# CORPORATION OF THE TOWNSHIP OF ESQUIMALT

## Staff Report

Report No. DEV-20-022

Rezoning Application -1048 Tillicum Road

1 GROUND FLOOR PLAN-FULL WIDTH GARAGE  
 SUPP-1 SCALE= 1/8"=1'-0" [399.9 sf] 37.15 sm

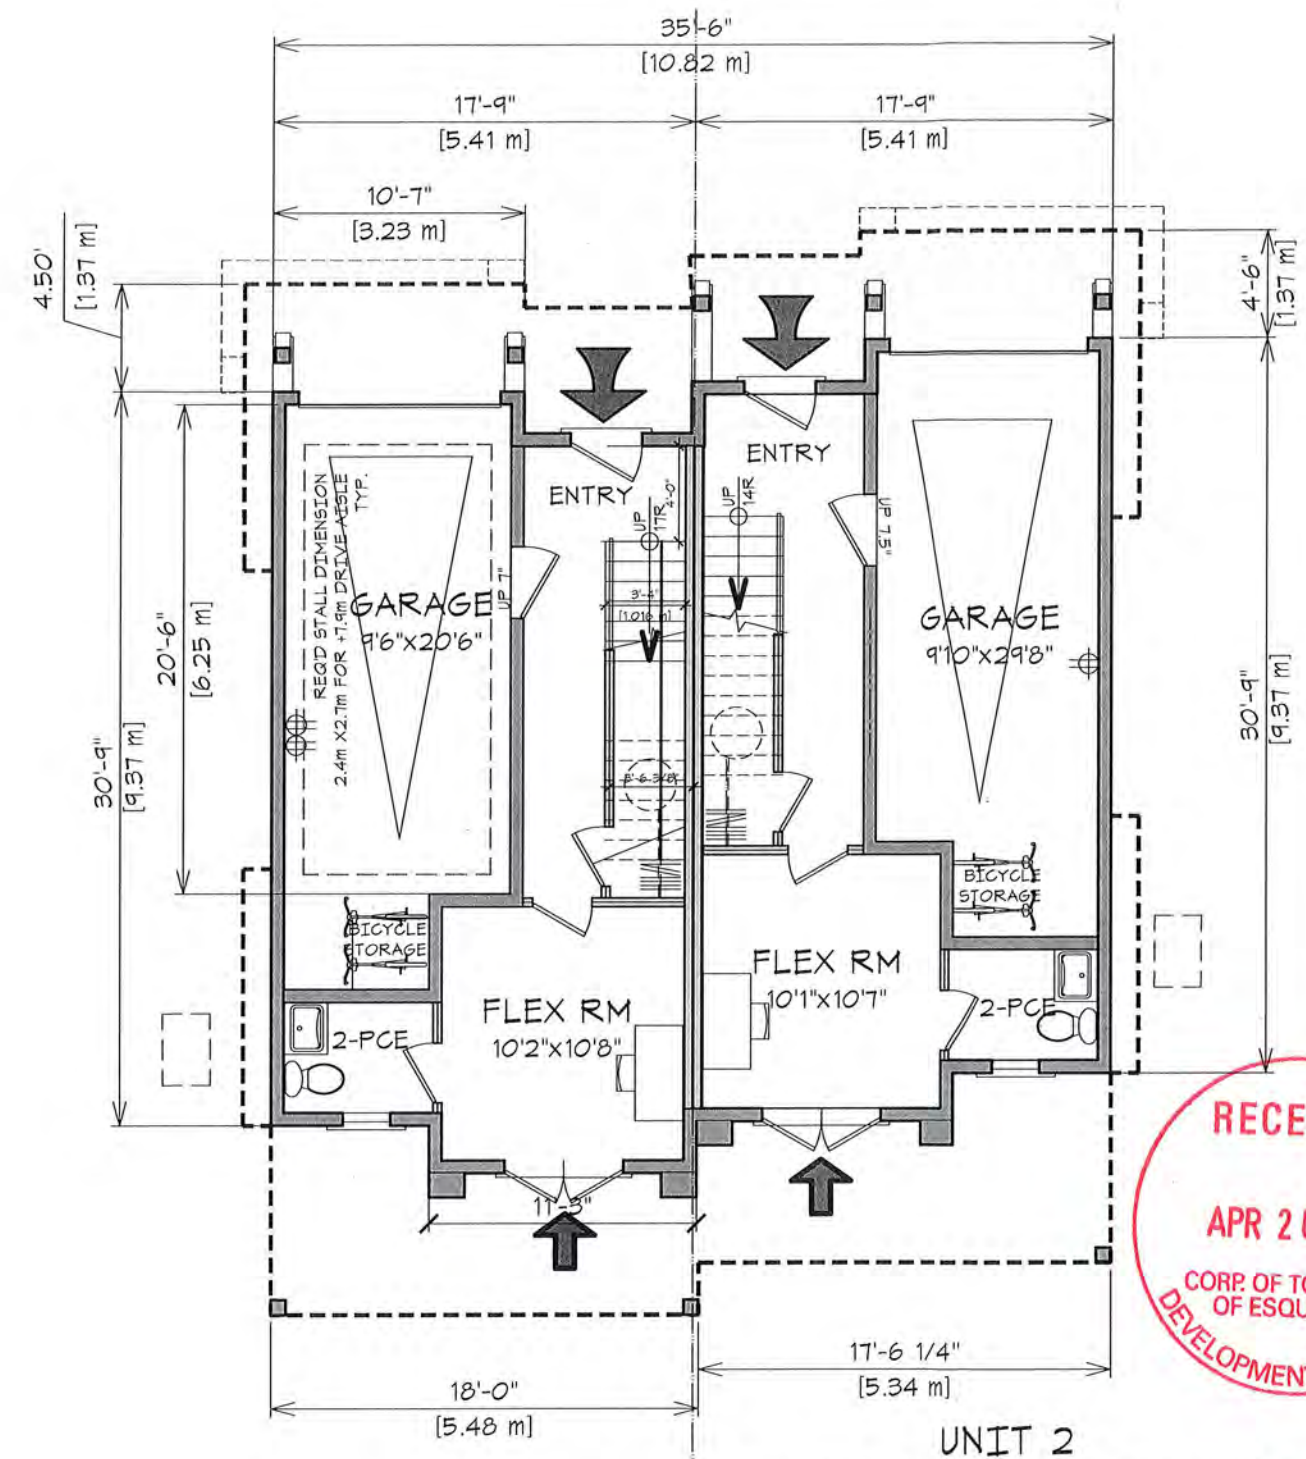
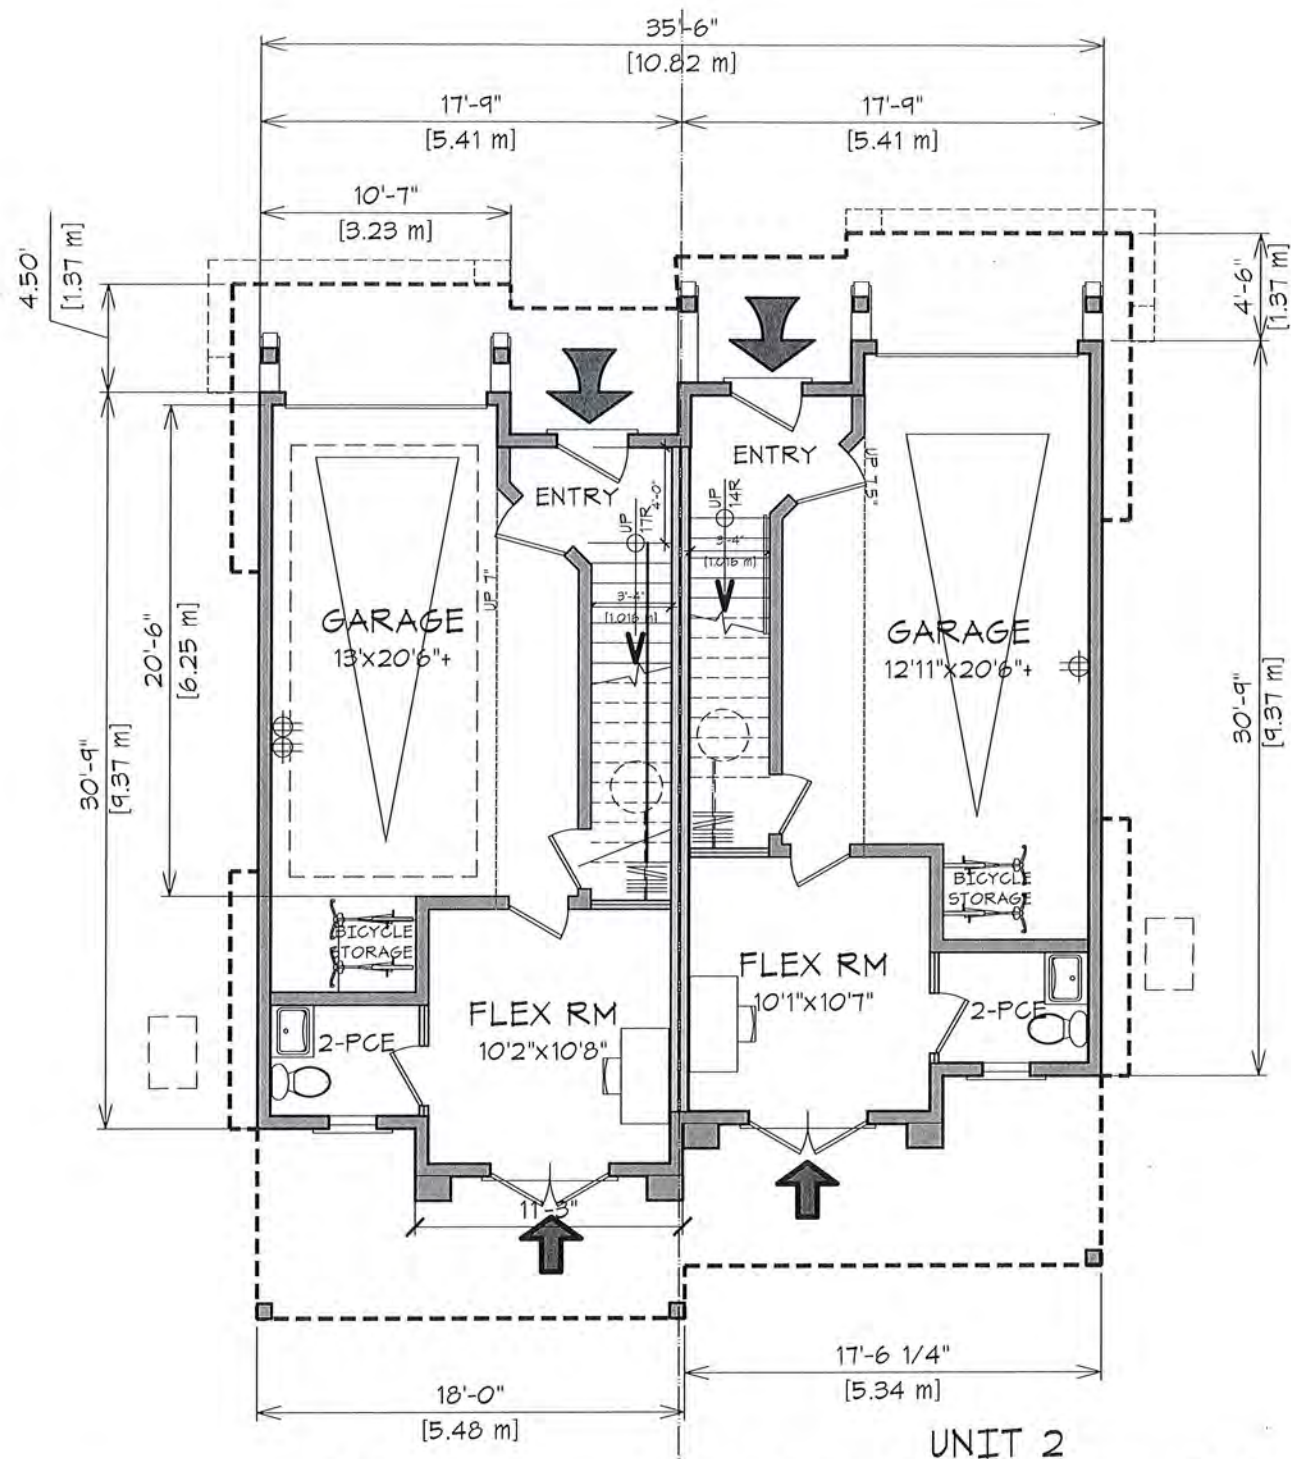
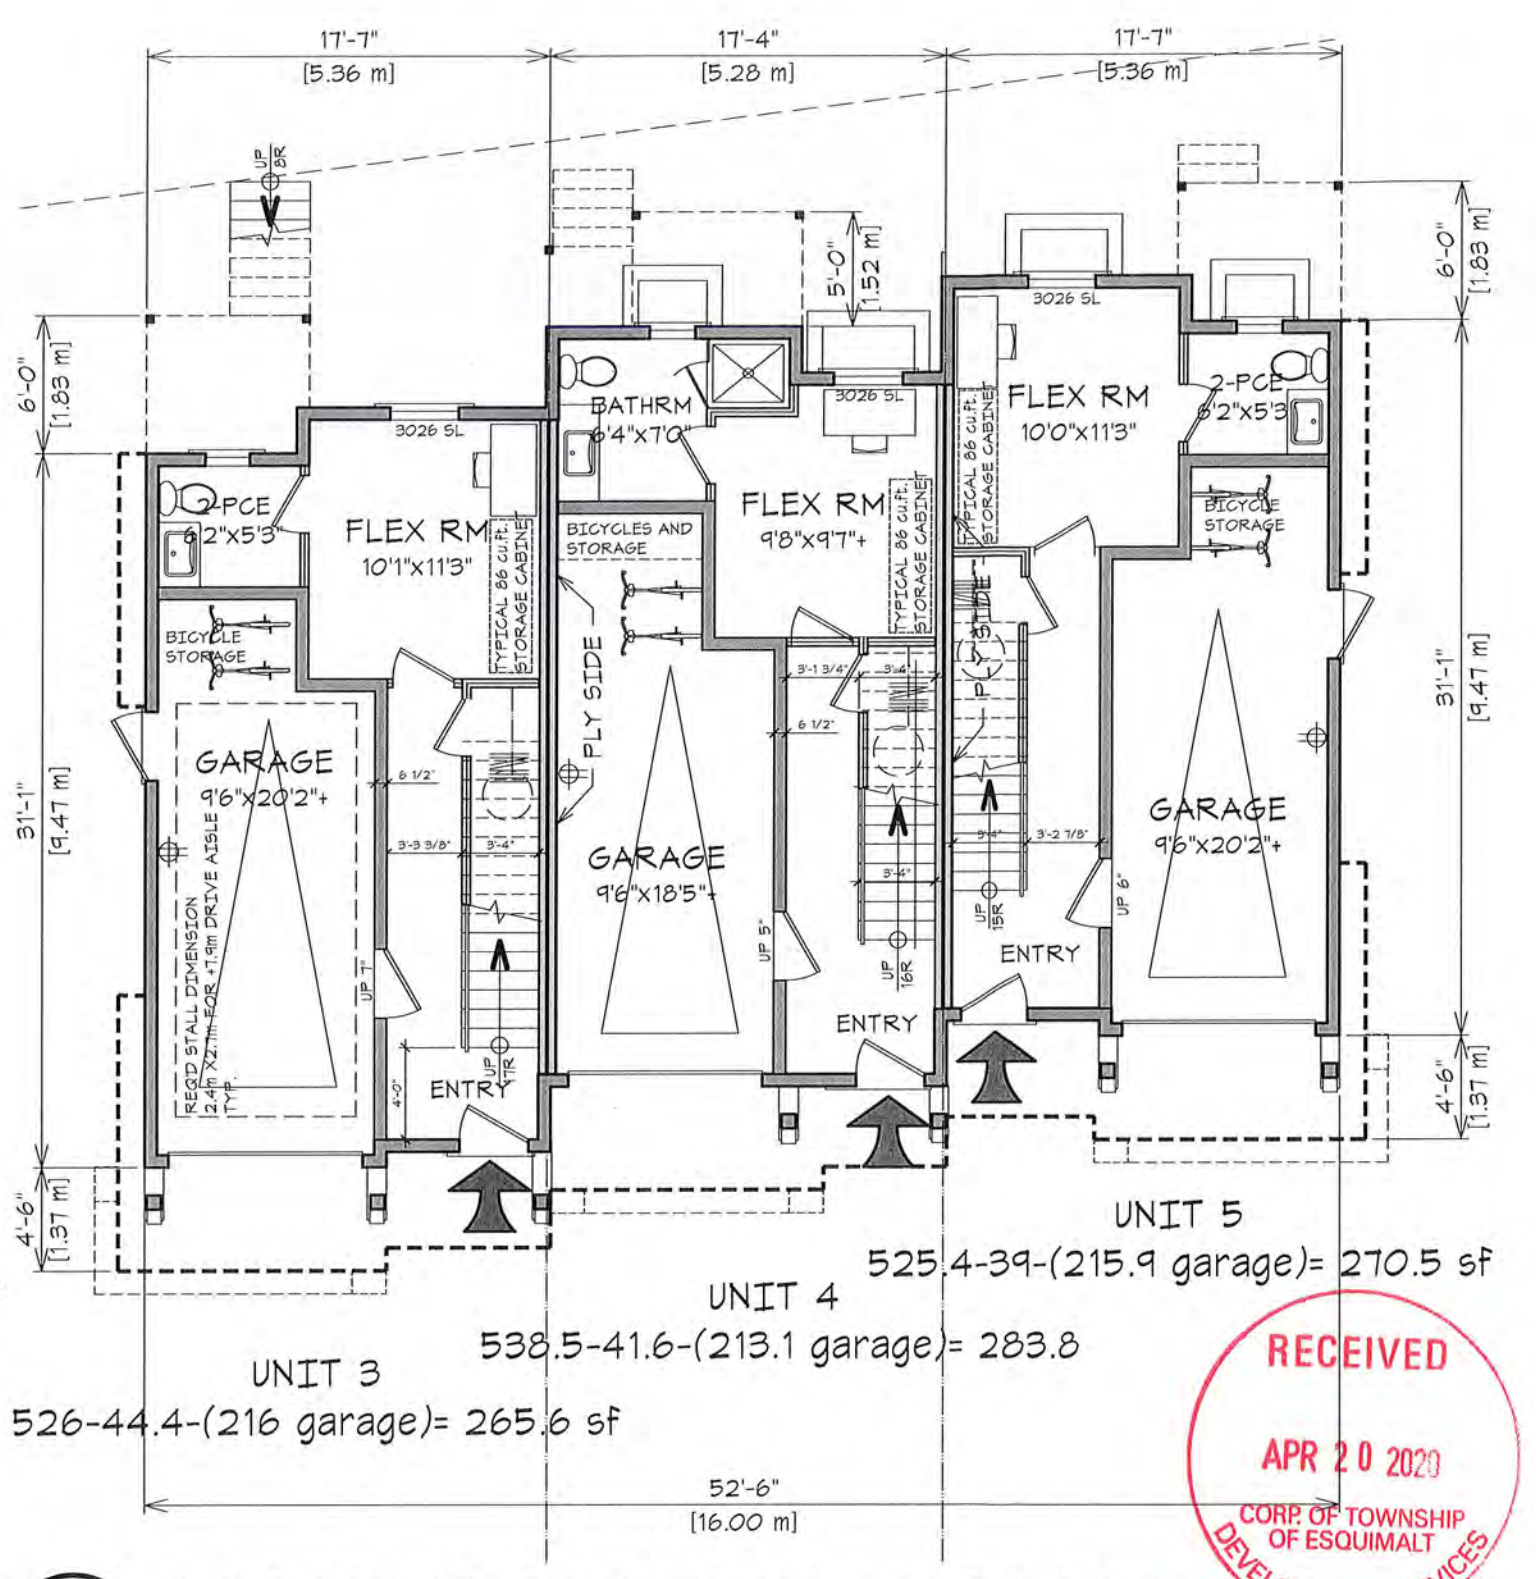
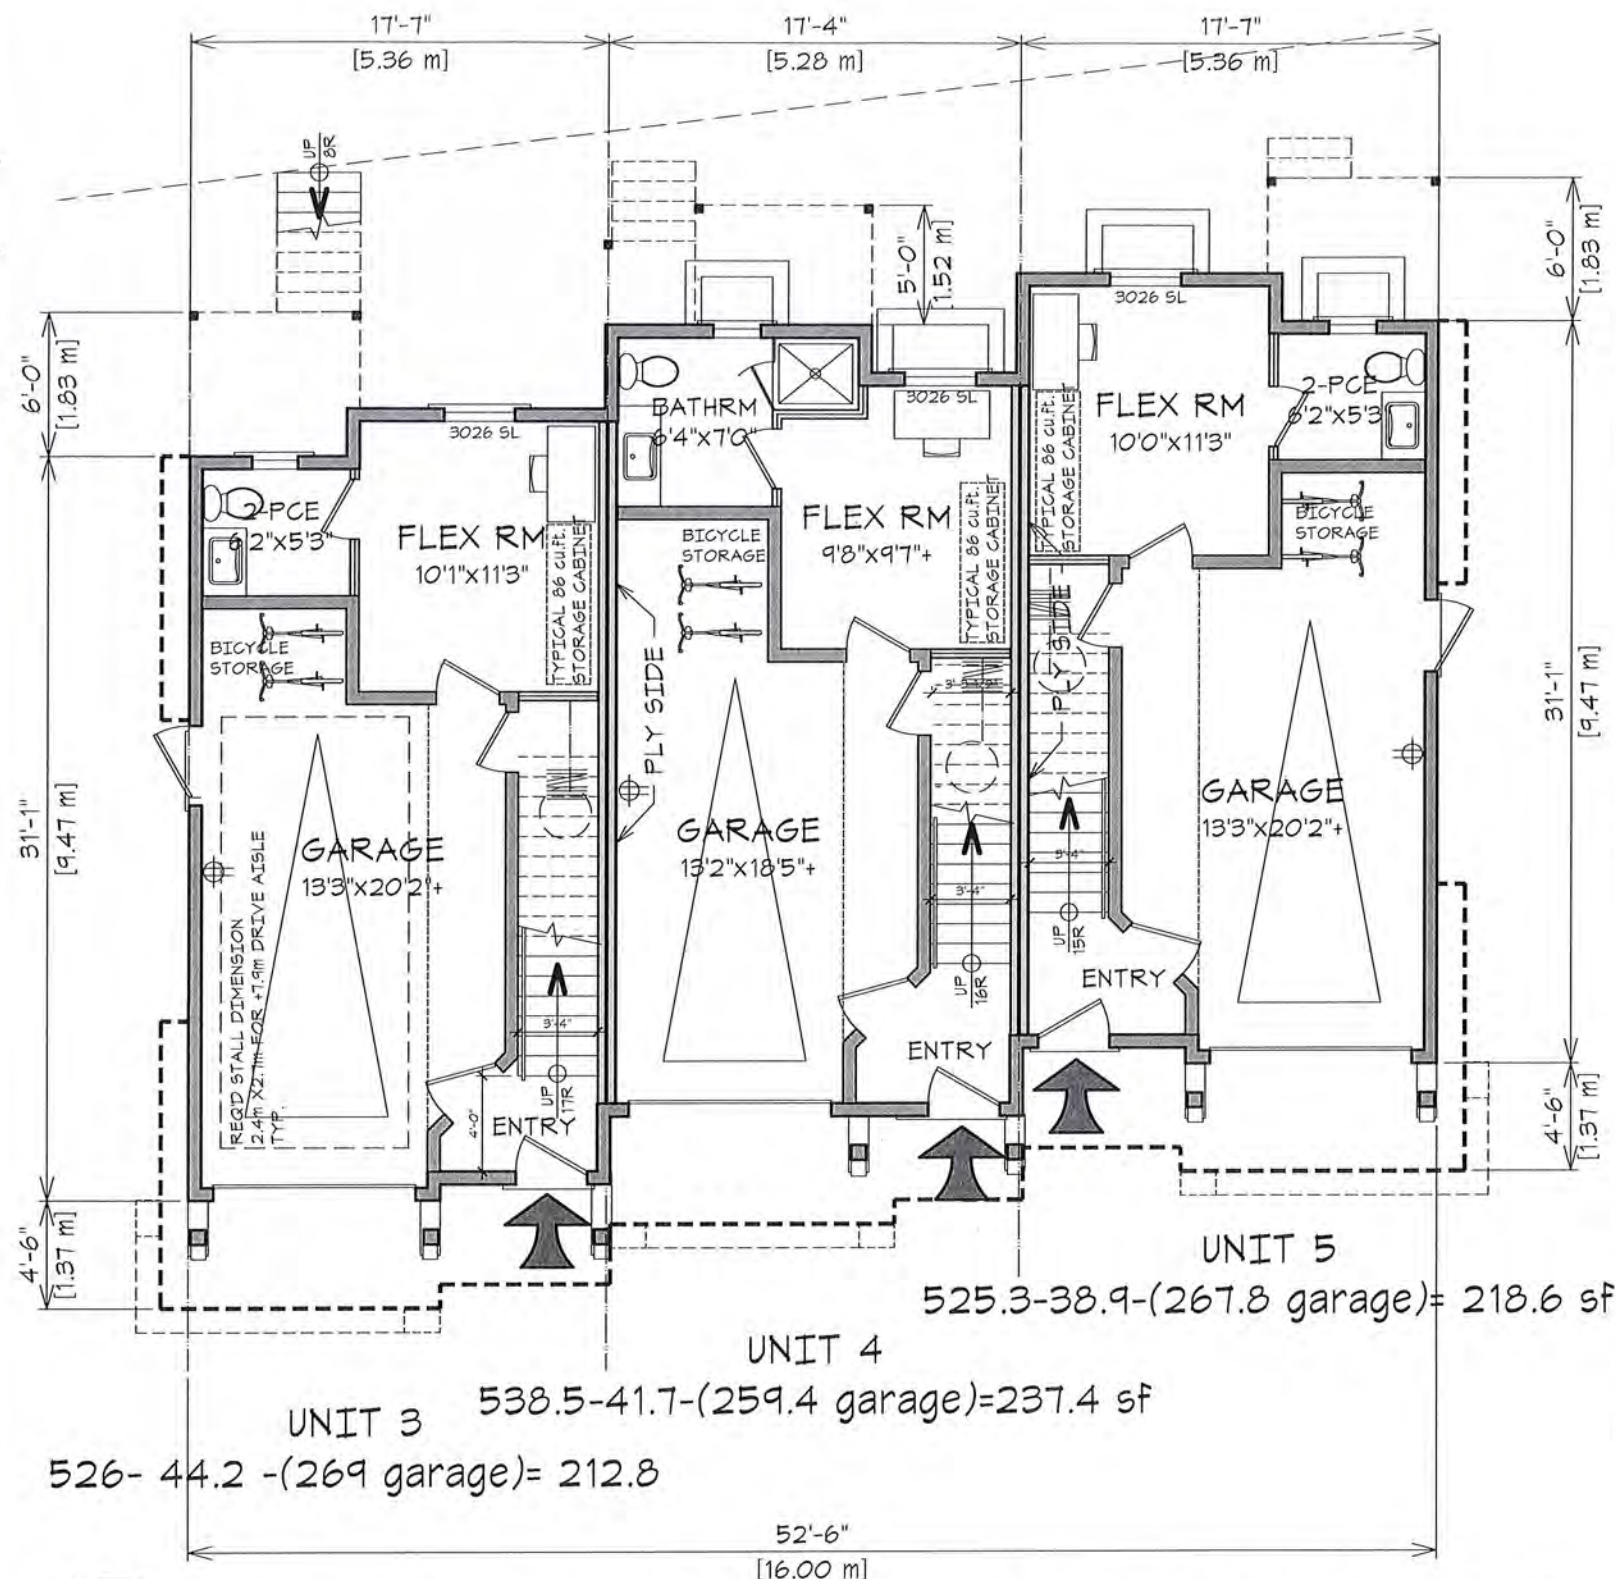
Council considered Bylaw No. 2994 on March 16, 2020 reading it a first time but withholding consideration of second reading until the applicant presented amended plans that increased the width of the garages and improved storage options in the proposed design.

In response to this direction the applicant has revised the plans to provide the option to the first purchaser of a unit to install the lower floor hallway wall or retain a wider garage parking space, depending on the purchasers needs. The applicant has also noted that a notable amount of storage can be achieved in the lower floor flex room through the installation of a floor to ceiling cabinetry which occupies limited floor space and does not undermine the functionality of the flex room. These proposed design approaches would be consistent with design options presented on pages SK-2, SUPP-1 and SUPP-2 of Appendix D of Staff Report DEV-20-022.

Garage parking spaces meet the dimension requirements of Parking Bylaw No. 2011 and should a purchaser opt to eliminate the lower floor hallway wall these spaces notably exceed the parking space minimum width regulations.
